Access Compliance Report Public Rights-of-Way (Curb Ramps)

Intersection ID: 2527Main Street: CAMBRIDGE_BAY_DRCross Street: LAGRANDE_DRLocation:NEADA ID: 53EFA59633C6Ramp Type: PerpDiagInitial Pass/Fail: FailOverall Compliance: NoSeverity Score:10

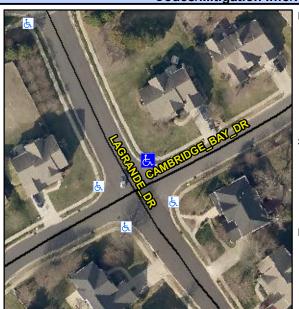
Not Found, R304.5.1, R304.5.3

Field Measurements/Component Compilance					
Compliance Description		Data	ta Compliance Description		Data
N/A	Ramp Length (in)	47.0	Yes	Ramp Slope (%)	6.8
No	Ramp Width (in)	41.0	No	Ramp XSlope (%)	3.5
N/A	Flare Type LT	N/A	N/A	Flare Type RT	N/A
N/A	Flare Slope LT (%)	N/A	N/A	Flare Slope RT (%)	N/A
N/A	Flare Traversable LT?	N/A	N/A	Flare Traversable RT?	N/A
N/A	Landing Length (in)	N/A	N/A	DWS Provided?	N/A
N/A	Landing Width (in)	N/A	N/A	DWS Contrast?	N/A
N/A	Landing Slope (%)	N/A	N/A	DWS Length (in)	N/A
N/A	Landing X Slope (%)	N/A	N/A	DWS Full Width?	N/A
N/A	Landing Curb? (Y/N)	N/A	N/A	DWS Offset (in)	N/A
N/A	Shared Landing?	N/A			
N/A	Gutter Ponding?	N/A	N/A	Gutter Slope (%)	N/A
N/A	Gutter Lip Ht (in)	N/A	N/A	Gutter X Slope (%)	N/A
N/A	Painted X Walk1?	No	N/A	Painted X Walk2?	No
	X Walk 1 Direction	To W		X Walk 2 Direction	To S
N/A	X Walk 1 Width (in)	N/A	N/A	X Walk 2 Width (in)	N/A
	X Walk 1 Slope (%)	4.4		X Walk 2 Slope (%)	1.6

Remove & Replace Curb Ramp With Two New Directional Ramps or Equivalent.
